UNITED STATES PATENT AND TRADEMARK OFFICE

APPLICATION NO.	FILING DATE	FIRST NAMED INVENTOR	ATTORNEY DOCKET NO.	CONFIRMATION NO.
10/518,748	07/26/2005	Hermann Raabe	095309.55705US	1320
23911	7590	09/25/2007	EXAMINER	
CROWELL & MORING LLP INTELLECTUAL PROPERTY GROUP P.O. BOX 14300 WASHINGTON, DC 20044-4300			PILKINGTON, JAMES	
		ART UNIT	PAPER NUMBER	
		3682		
		MAIL DATE	DELIVERY MODE	
		09/25/2007	PAPER

DETAILED ACTION

Figure 1. Ganser's torque-transmitting joint.

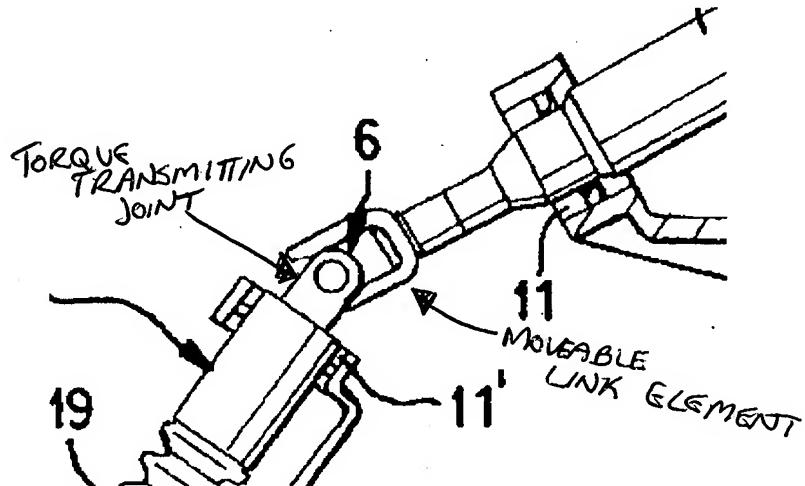
Re clm 1, Ganser discloses a steering spindle (8) which bears a steering wheel (2), a steering shaft (5) connected to the steering spindle (8), a torque-transmitting joint (See Fig 1 below) forming the connection between the steering spindle (8) and the steering shaft (5) and a second moveable link element (Fig 1 below).

Figure 2. Bouchard's extensible joint for motor vehicles. The examiner has added character references to better explain the drawing.

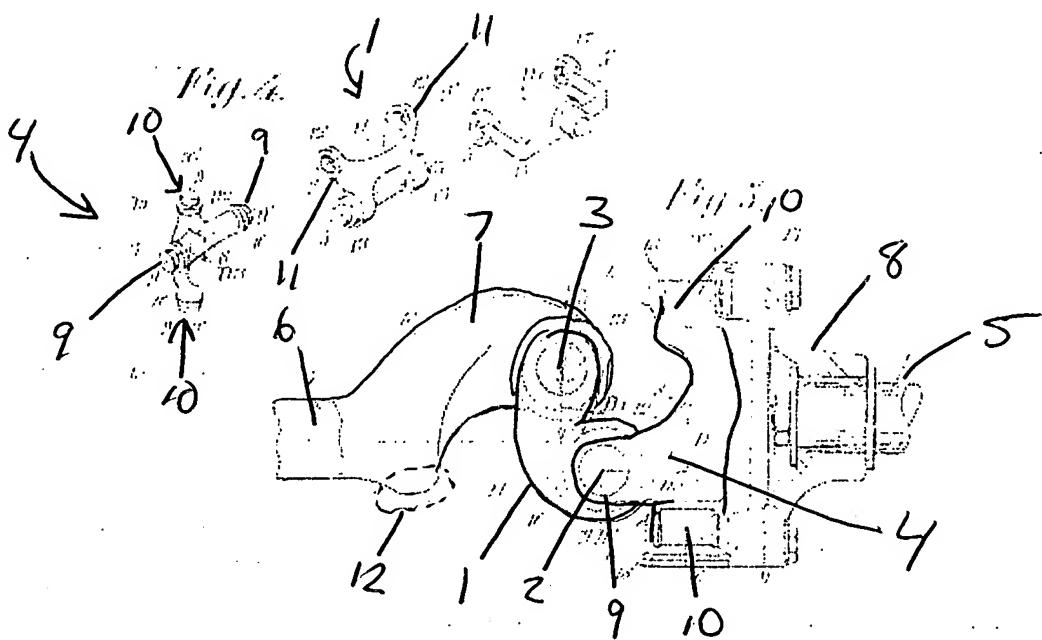
Bouchard teaches a moveable link element (Fig 4/5 or see Fig 2 below) for the purpose of allowing for relative variations of the orientations and respective axial

positions (col 1) comprising at least one coupling member (1) with two parallel axes of rotation (2,3), and a spigot cross element (4) being coupled to the end of the steering spindle (5) which lies opposite the steering wheel, one axis of the spigot cross element (4) forming an axis of rotation (2) for the coupling member (1), wherein the steering shaft (6) has a flange (7) which ends at a distance from the longitudinal axis of the steering shaft, the flange executing a pivot movement about the upper axis of rotation (3) of the coupling member (1).

Re clm. 2, Bouchard discloses the spigot cross element (4) being mounted in a forked joint (8). From the combined invention of Ganser and Bouchard discussed above said forked joint will be arranged at the end of the steering spindle which lies opposite the steering wheel.

Re clm. 3, Bouchard discloses two transverse spigots (9) of the spigot cross element (4) form a transverse bolt of the coupling member (1).

Re clm. 4, Bouchard discloses two longitudinal spigots (10) of the spigot cross element (4) form a pivot axis of the forked joint (8).

Re clm. 5, Bouchard discloses that the coupling member (1) comprises two side plates (11) through which two transverse bolts pass, the transverse bolts form the axes of rotation (2,3) of the coupling member (1).

Re clms. 6, 8, 10, 12 and 14, Bouchard discloses the flange being provided with an additional mass (12).
